SUMMARY RESPONSE TO FURTHER INFORMATION REQUEST

P.A. REF. NO. SDZ 22A/0011

**PROPOSED DEVELOPMENT OF A PRIMARY SCHOOL AT THOMAS OMER WAY,
BALGADDY, LUCAN, CO. DUBLIN**

STEPHEN WARD PLANNING CONSULTANTS LIMITED

Figure 1 – Revised Proposal

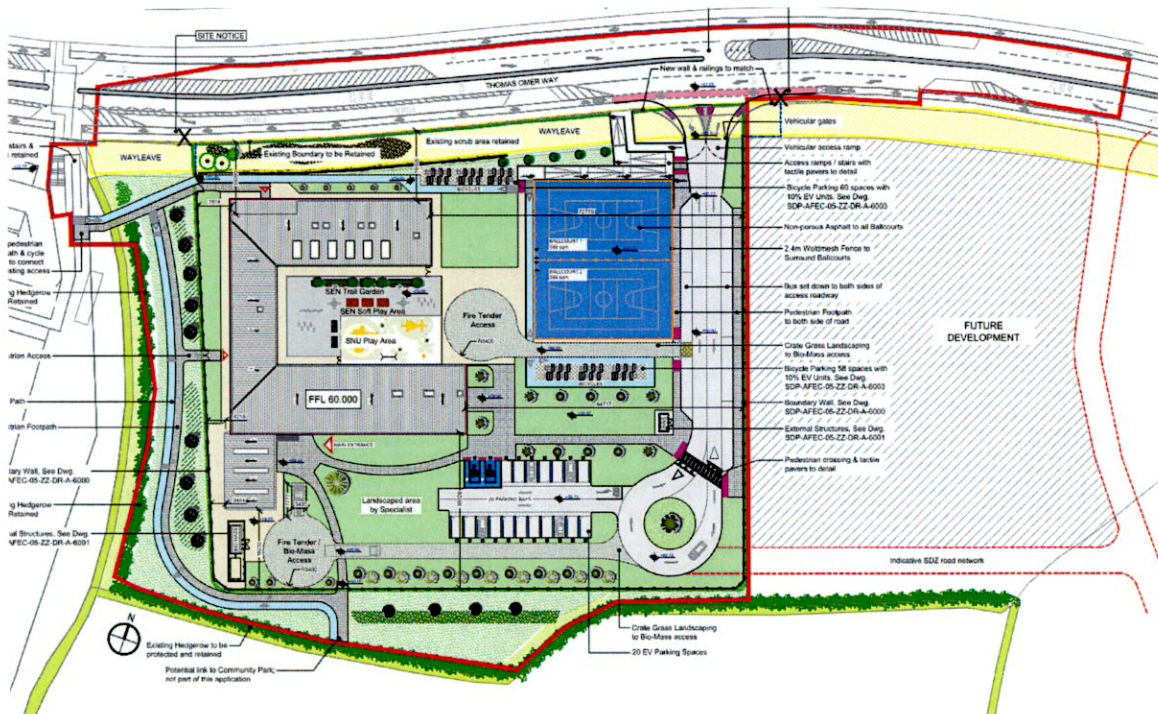
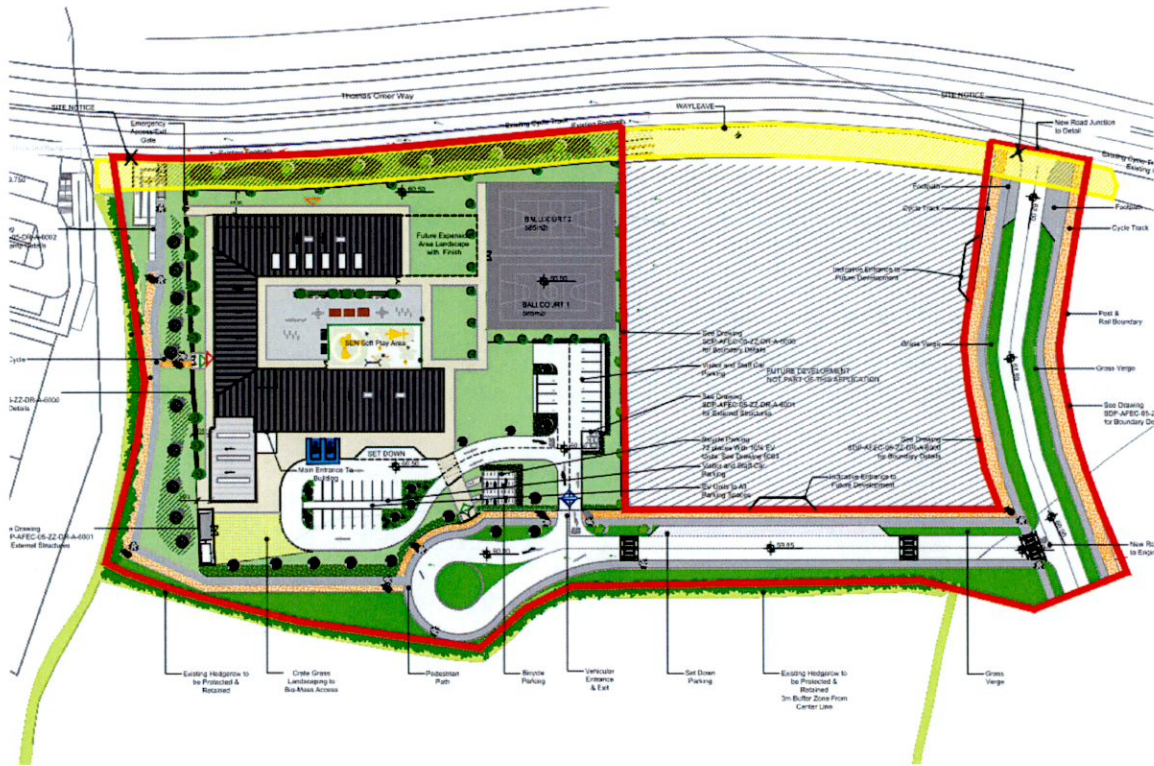
In order to fully and comprehensively address the Further Information request, specifically Items 1,2,3,4 and 5, the design and layout of the originally submitted proposal has been subject to a series revisions. The principal revisions to the scheme can be summarised as follows –

- Application Site amended from 1.91 hectares to 2.09 hectares to facilitate changes to the road layout on Thomas Omer Way and pedestrian/cyclist access off Thomas Omer Way via the existing pedestrian cyclist access to the NW of the site.

- Direct vehicular access off Thomas Omer Way now provided c. 100 m west of originally proposed 'link road' access.
- Revisions to the existing road layout on Thomas Omer Way including modification of both east/west traffic lanes, between pedestrian traffic lights at existing school for approximately 210 meters westwards comprising the omission of bus lanes in both directions; lane reductions to allow for access into new site; creating a break in the central median opposite entrance to new school and to widen a section of the median immediately to the east of the new entrance; new two-way entrance into new school; with a left (west) exit only; modifications to southern bicycle lane to allow safe access across proposed new entrance and the installation of a new kerbed island within new entrance to force the left-out exit.

- Omission of emergency pedestrian access gate in NW corner from Thomas Omer Way.
- Revisions to internal road layout including increased set back of the internal turning circle/access road from 3.6m to 6.7 meters from the Barony Hedge to the south

- Reduction in overall car parking provision to 20 no. spaces to comply with standards for Zone 1 as set out in Table 12.25 of the Development Plan i.e. 1 space per classroom plus 2 no. disabled spaces.

- Bicycle parking racks relocated to more convenient and accessible locations within the site i.e. to the north of the proposed building at the termination of the cycle lane running along the west of the site from Thomas Omer Way. A second bicycle parking area is provided to the south of the proposed ball courts in proximity to the central courtyard incorporating on the main entrances.

- Gross Floor Area of proposed school building increased to 3,390 sq.m from 3,355 sq.m
- Building height increased from 9.277m to 10.09m.
- Revisions to all elevations including changes in size and positioning of opes and of proposed external finishes and materials to higher quality materials to include a mix of render, brick and aluminium cladding.
